ISSUE: Alterations and Signage

APPLICANT: Fransmart for Sandella's Flatbread Cafe

LOCATION: 320 King Street

BAR CASE #2009-0020

Figure 9: Elevation and plan showing proposed alterations and signage

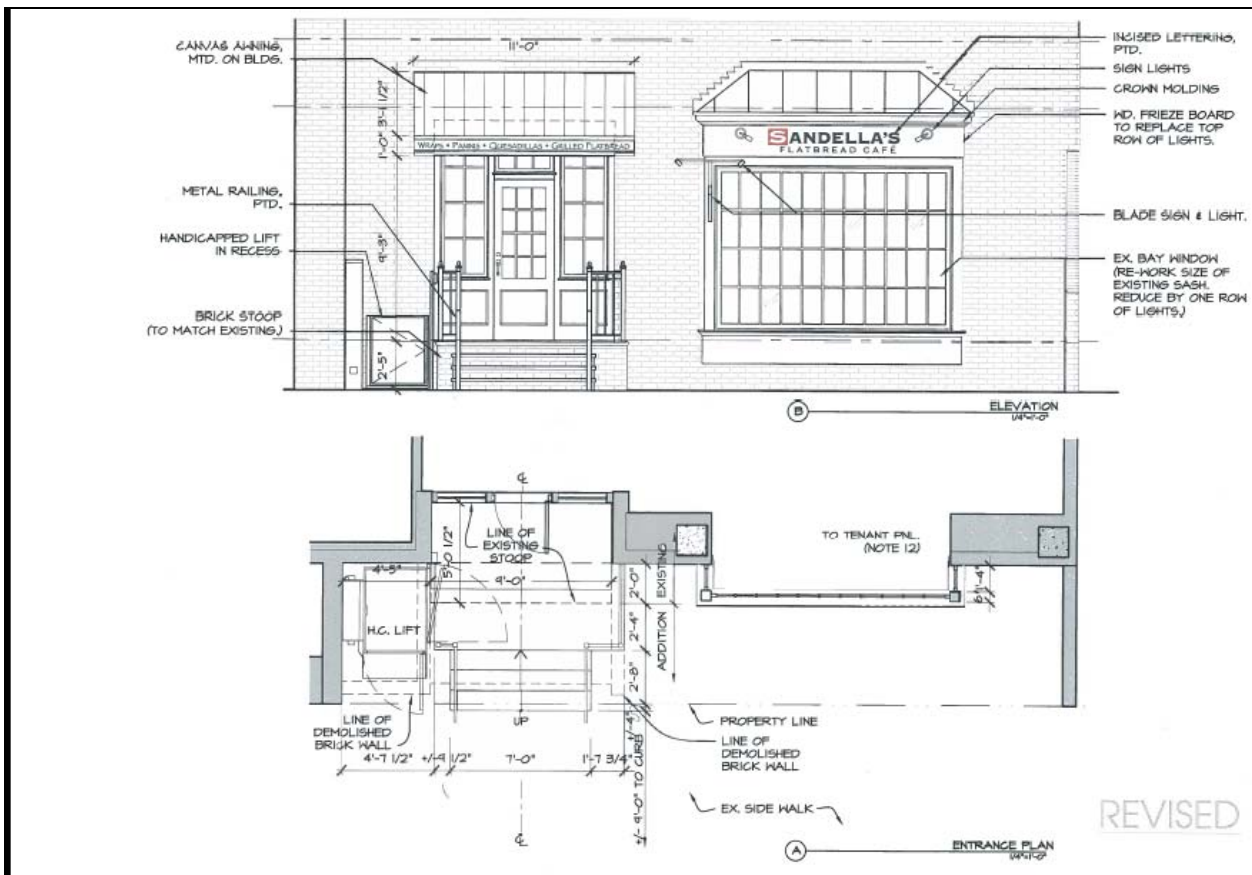
With the original submittal, Planning & Zoning Staff and the City's Transportation and Environmental Services (T&ES) had concerns that the proposed new stoop and stairs would encroach 2 feet into the right-of-way and impact accessibility around the new stoop and the adjacent tree well to the east. Since the deferral of the prior submittal, the applicant's agent has met with Staff to seek other solutions that accomplish the requirements for ADA accessibility, while not compromising the accessibility and pedestrian flow along the sidewalk, or interrupt the street wall character. With this current scheme, Staff believes this goal has been achieved with the exception of one feature. Staff is concerned because the proposed new rails terminate a minimum of approximately 1 foot 3 inches into the right-of-way. Staff recommends that the applicant design and construct the railings so that they do not project beyond the step that is proposed to encroach 4 inches into the right-of-way. If the applicant cannot or chooses not to comply with this recommendation, then Staff recommends deferral for restudy to explore options that do not necessitate railings that project into the right-of-way. Such options may include constructing a side-loaded stair to the west of the stoop, as originally discussed with the architect prior to application submittal.

1. That the applicant delete the proposed new hanging sign; and,
2. That the applicant revise the new handrail design so that it curves or turns to the sides of the new stair and so that it does not extend beyond the proposed step shown to encroach 4 inches into the right-of-way, and that the revised configuration be submitted to Staff for approval prior to applying for the building permit.

- C-3 Awnings must comply with all applicable requirements of USBC 3105.3 and 3202.3.1 Retractable and fixed awnings must have a minimum 7 foot clearance from a sidewalk to the lowest part of the framework or any fixed portion of any retractable awning is required. Retractable awnings must be securely fastened to the building and can not extend closer than 24 inches in from the curb line (USBC 3202.3.1).

Figure 10: Proposed hanging sign

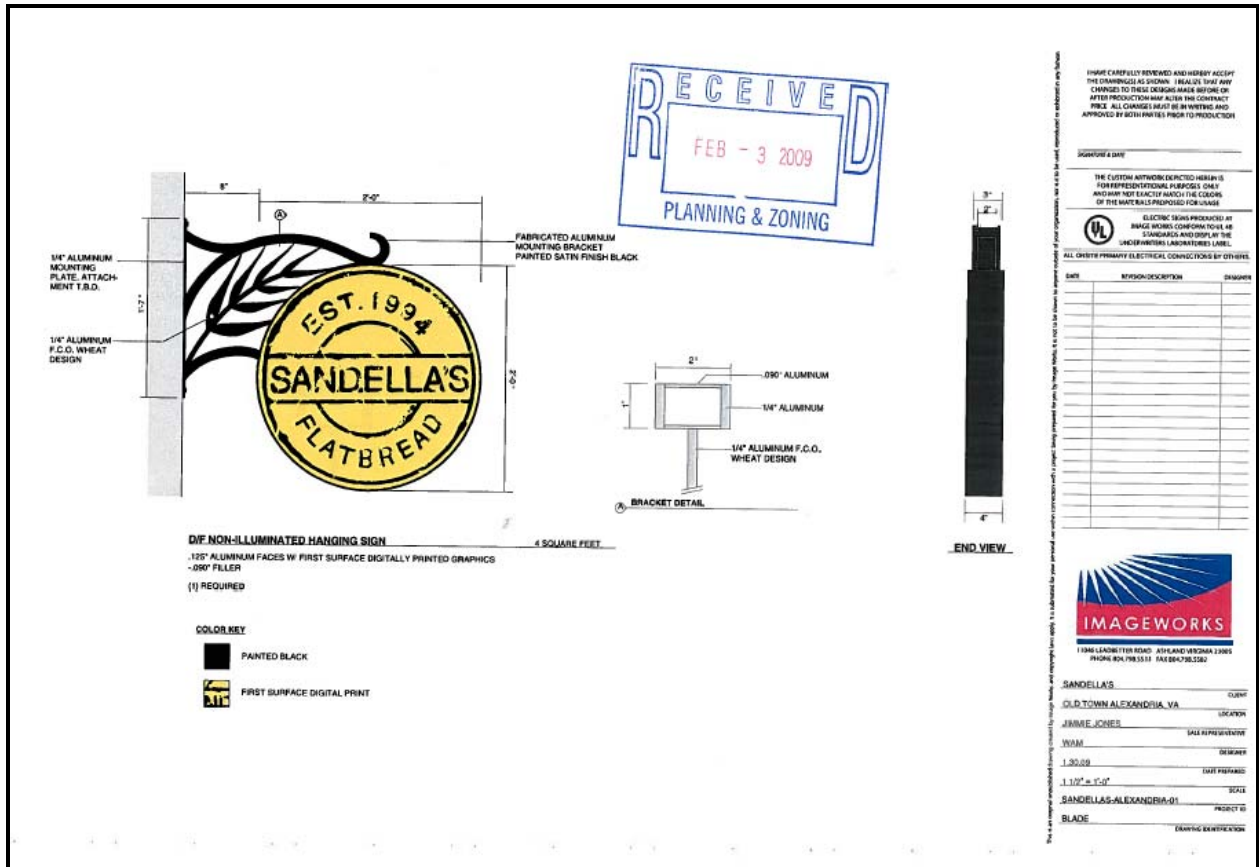
In respect to the proposed signage, the *Design Guidelines* generally recommend one sign per business. In the opinion of Staff, the three proposed signs are excessive. Because this is a new restaurant and because this retail portion of 320 King Street is set back approximately 5 feet from the buildings on either side, Staff believes that two signs would be appropriate in this location and recommends that the hanging sign be deleted. The frieze sign will be the most visible of the signs

and the awning sign will help to announce the main entrance to the restaurant. Furthermore, the text and the color scheme of the hanging sign do not appear to stylistically relate to the awning and frieze signs.

- C-2 Projecting, hanging signs must comply with USBC [H103-H107, H112] for type of materials, maximum projection, vertical clearance below all parts of the sign, and additional loads.

1. That the applicant delete the proposed new hanging sign; and,
2. That the applicant revise the new handrail design so that it curves or turns to the sides of the new stair and so that it does not extend beyond the proposed step shown to encroach 4 inches into the right-of-way, and that the revised configuration be submitted to Staff for approval prior to applying for the building permit.
